# Access Compliance Report

## Public Rights-of-Way

### (Curb Ramps)

Intersection ID: 11980	Main Street: ALLEN_ST	Cross Street: E_17TH_ST	Location: NE
ADA ID: B018642CE93E	Ramp Type: Directional1	Initial Pass/Fail: Pass	Overall Compliance: No
Severity Score: 0			
Codes/Mitigation Info/Possible Solution		Field Measurements/Component Compliance

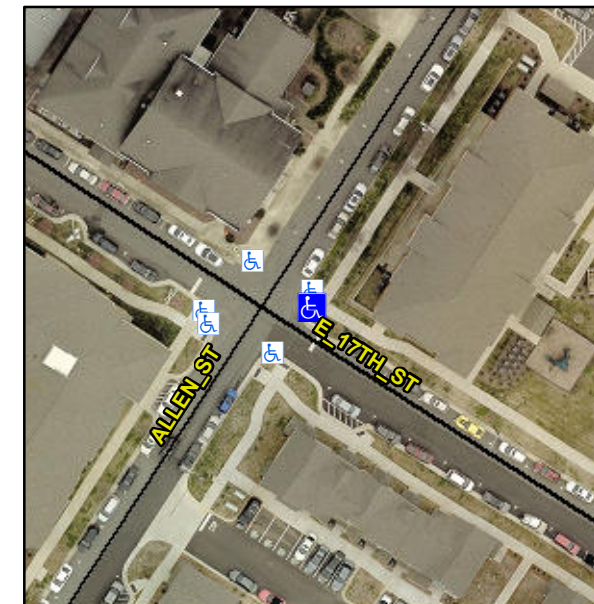
**R304.5.3, R302.7**

Compliance	Description	Data	Compliance	Description	Data
N/A	Ramp Length (in)	88.0	Yes	Grade Break?	Yes
Yes	Ramp Width (in)	69.0	Yes	Grade Break Slope (%)	3.1
Yes	Ramp Slope (%)	4.2	No	Grade Break XSlope (%)	5.8
Yes	Ramp XSlope (%)	1.9			
Yes	Flare Type LT	N/A	Yes	Flare Type RT	N/A
N/A	Flare Slope LT (%)	N/A	N/A	Flare Slope RT (%)	N/A
N/A	Flare Traversable LT?	No	N/A	Flare Traversable RT?	No
Yes	Landing Length (in)	72.0	Yes	DWS Provided?	Yes
Yes	Landing Width (in)	71.0	Yes	DWS Contrast?	Yes
Yes	Landing Slope (%)	0.0	Yes	DWS Length (in)	24.0
Yes	Landing X Slope (%)	0.1	Yes	DWS Full Width?	Yes
N/A	Landing Curb? (Y/N)	No	Yes	DWS Offset LT (in)	2.0
N/A	Shared Landing?	Yes	Yes	DWS Offset RT (in)	14.0
No	Gutter Ponding?	Yes	Yes	Gutter Slope (%)	2.7
Yes	Gutter Lip Ht (in)	0.0	No	Gutter X Slope (%)	4.9
N/A	Painted X Walk1?	No		Road Slope (%)	4.6
	X Walk 1 Direction	To S		Road X Slope (%)	5.6
	X Walk 1 Width (in)	N/A		Clear Space?	Yes

**Remove & Replace Entire Ramp.  
Remove & Replace Gutter.**
